## REQUEST FOR PROPOSAL (RFP) ADDENDUM

Addendum No.: 1

RFP: District Asphalt Repairs

Title: Little Miami School District Asphalt Repairs

Revision 1 CHANGE

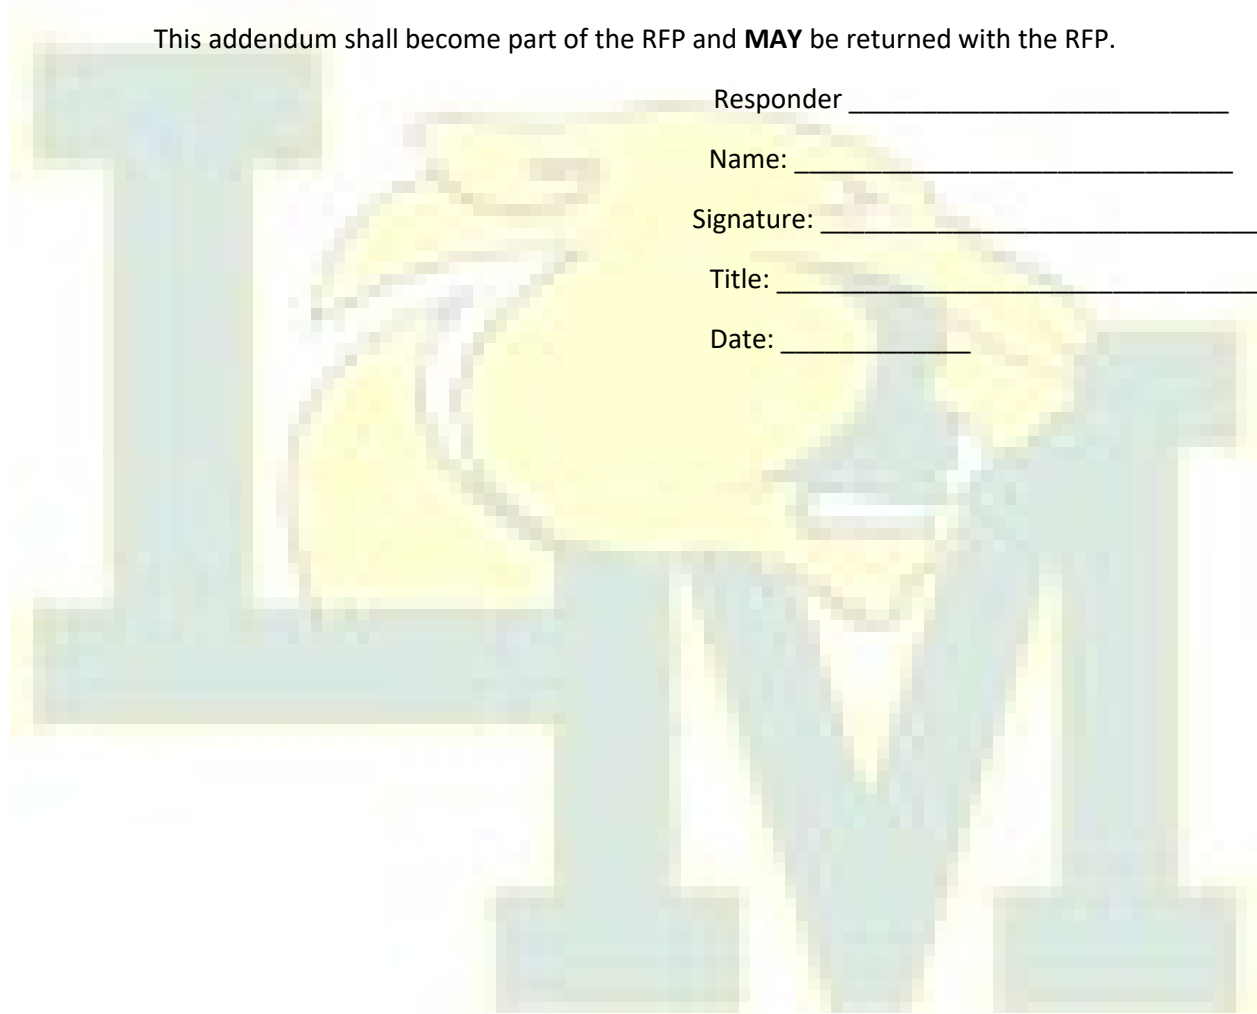
Page 5, Section 2.2, Sub Sections a., b., c., and e.

- a. Pot Hole Repair in area A and C, Marked Out and Squared and Excavated to at least 2"
  - i. Area "A" Approximately 44 square yards
  - ii. Area "C" Approximately 18 square yards

- b. Hot Rubber Crack Sealing in area A and C – Cracks 5' or longer and singular in form.
  - i. Area "A" Approximately 10,500 linear feet
  - ii. Area "C" Approximately 7,260 linear feet

- c. Seal Coat ~~13,415 square yards of asphalt~~ in area A and C – Coating must meet or exceed Federal Specifications.
  - i. Area "A" Approximately 13,415 square yards

- ii. Area "C" Approximately 16,856 square yards
- d. Paint all Parking lines and stencils per existing configuration in all areas of work.
- e. Milling and Paving ~~of 1,470 square yards~~ in area B and D – Install, roll, compact 2" of ODOT #448 type 1 surface asphalt and seal transition joints as required.

- i. Area "B" Approximately 1,470 square yards
  - ii. Area "D" Approximately 5,420 square yards
- f. Removal and Proper disposal of all spoils from job site
